## Errata for “On-The-Go Supplement to the USB 2.0 Specification,” Revision 1.0a

## Errata A: HS HNP Parameter Changes

### Issue: *TWTREV*, *TB\_FS\_BDIS* and *TB\_AIDL\_BDIS*

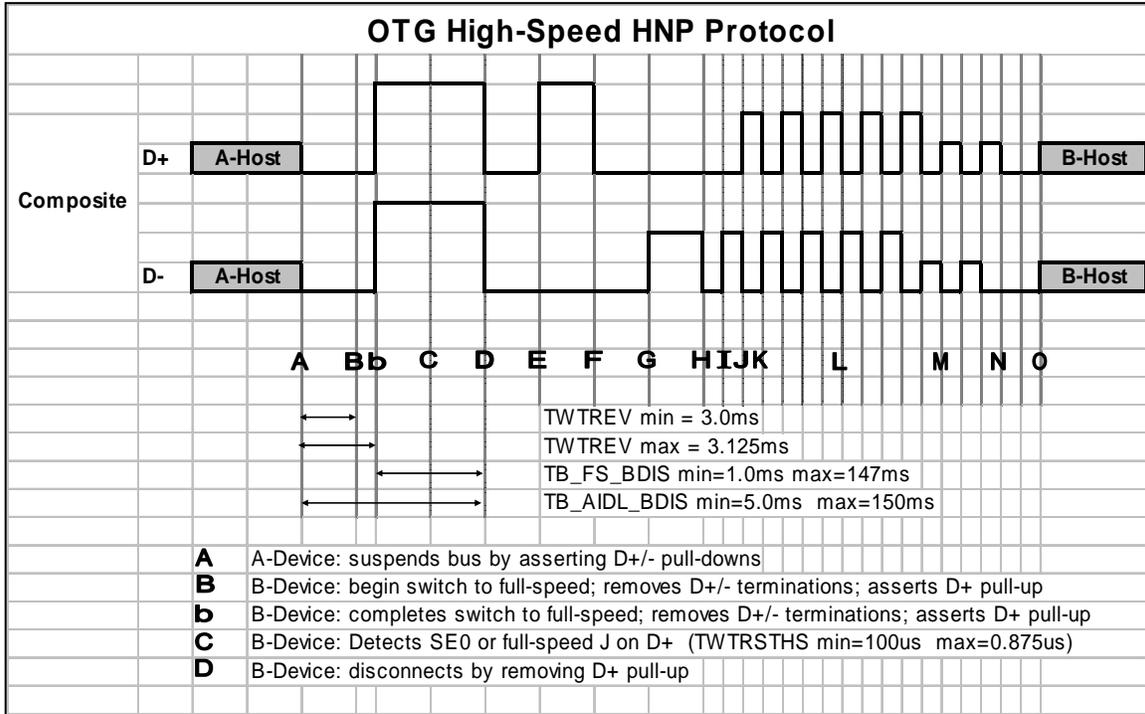
The parameters defined for high-speed HNP do not add up correctly. The affected parameters are *TWTREV*, *TB\_FS\_BDIS* and *TB\_AIDL\_BDIS*. The above timeline depicts the high-speed HNP sequence as it currently exists in the OTG Supplement Revision 1.0a.

Change *TB\_FS\_BDIS* max from 147.0ms to 146.875ms. This allows:

$$\begin{array}{rcl}
 \text{TWTREV max} & + & \text{TB\_FS\_BDIS max} & = & \text{TB\_AIDL\_BDIS max} \\
 3.125\text{ms} & + & 146.875\text{ms} & = & 150\text{ms}
 \end{array}$$

Change *TB\_AIDL\_BDIS* min from 5.0ms to 4.0ms. This allows:

$$\begin{array}{rcl}
 \text{TWTREV min} & + & \text{TB\_FS\_BDIS min} & = & \text{TB\_AIDL\_BDIS min} \\
 3.0\text{ms} & + & 1.0\text{ms} & = & 4\text{ms}
 \end{array}$$
